Re: **Proposed Palmer Lake, Co - Buc-ee's**

Subject: **Traffic Impact Study Review**

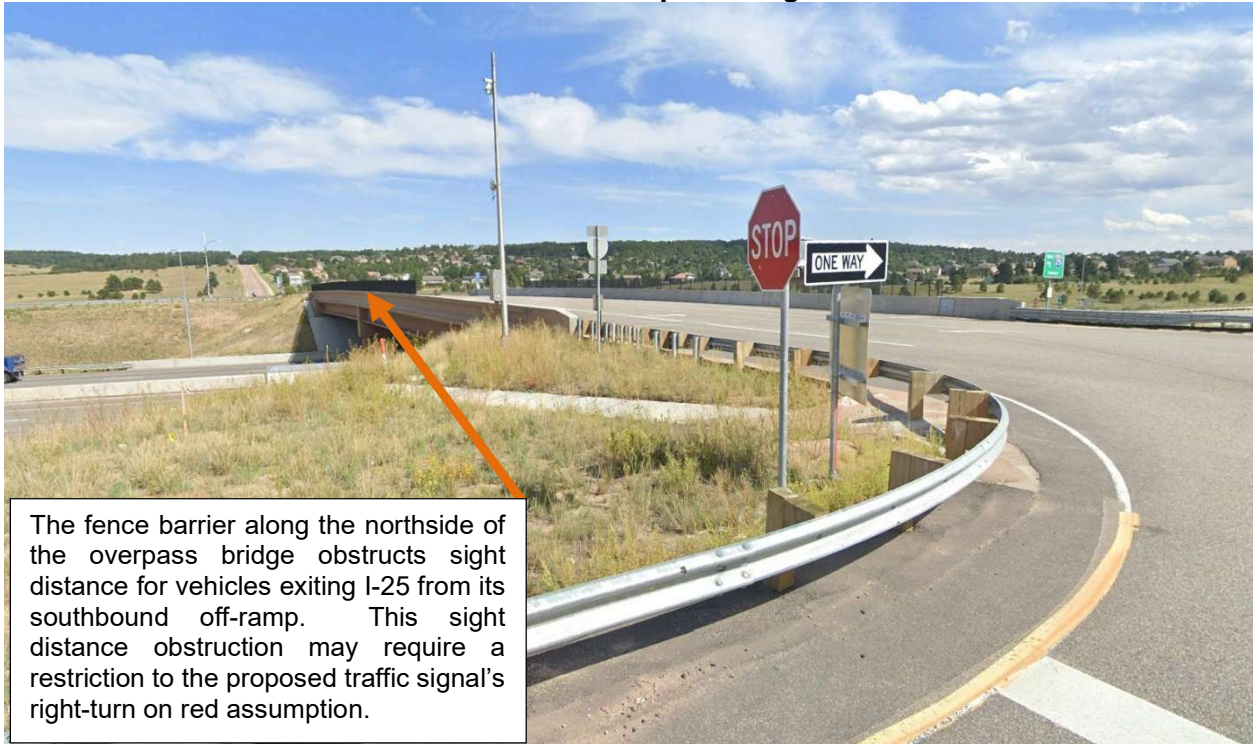
The fifth travel lane on the interchange bridge would require the reduction of existing striped shoulders. Therefore, the lateral offset requirements from the bridge wall need to be considered to ensure proper clearance from heavy vehicles. Additionally, the alignment of the relocated through lanes with the corresponding receiving lanes would need to be reviewed.

The relocation of the roadway edge lines would also impact sight distance considerations. The driver's viewing (eye) location would need to be shifted further back on each of the I-25 off-ramps. As shown below, with the shift in viewing location, the bridge wall and fence on top of the wall would likely obstruct the line on sight. While the installation of a traffic signal would help resolve sight distance concerns, right-turn-on-red (RTOR) maneuvers would likely be prohibited which would impact vehicle throughput and increase vehicle queues exiting the off-ramp.

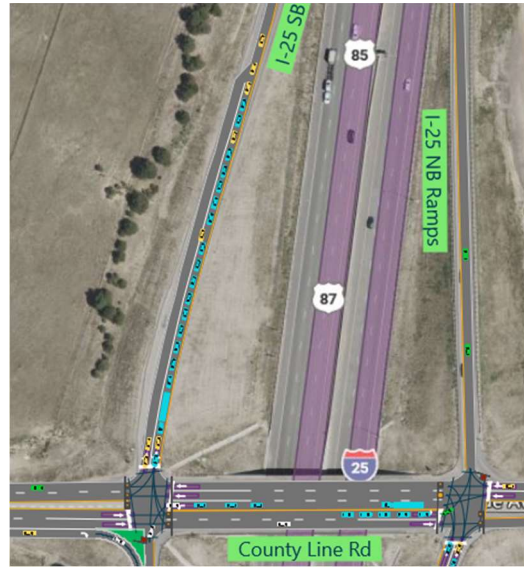
While a full analysis of the interchange and freeway operations would likely be required as part of the interchange modification process, a preliminary assessment was performed as part of this review. Specifically, the 2045 Synchro analysis from the Kimley Horn study was replicated based on the analysis worksheets and signal timing sheets provided in the report appendices. The following modifications were then made to support the SimTraffic model:

- The yellow and red times were increased from the Synchro default values (3.5 sec. yellow, 1.0 sec. red) to values (4.1-4.3 sec. yellow, 2.6 sec. red) consistent with CDOT's "Guidelines for Traffic Signal Vehicle Change and Clearance Intervals".
- Right-turns-on-Red (RTOR) was turned off for the I-25 Off-Ramp approaches to the proposed traffic signals for the sight distance constraints outlined above.
- The Link Origin-Destination settings were revised to account for the fact that few (if any) vehicles would exit I-25 at one intersection and re-enter at the adjacent intersection.

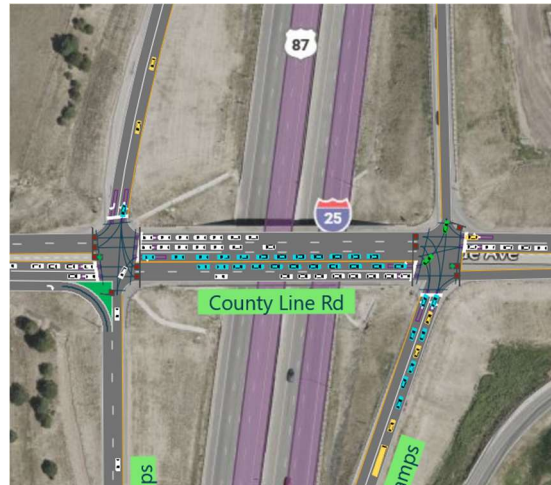
- During the PM peak hour, queues on the I-25 NB off-ramp would periodically extend to the gore point. It is noted that based on AASHTO standards and a design speed of 80 mph (posted 75 mph + 5 mph), an additional 705 feet of deceleration distance would be required to ensure mainline freeway operations are not impacted.

- The peak southbound left queue on the ramp would extend approximately 500 feet. The proposed right turn lane would need to be constructed to this length to avoid being blocked by the adjacent queue. The 705 feet of deceleration distance beyond the queue would extend to the taper area of the ramp.
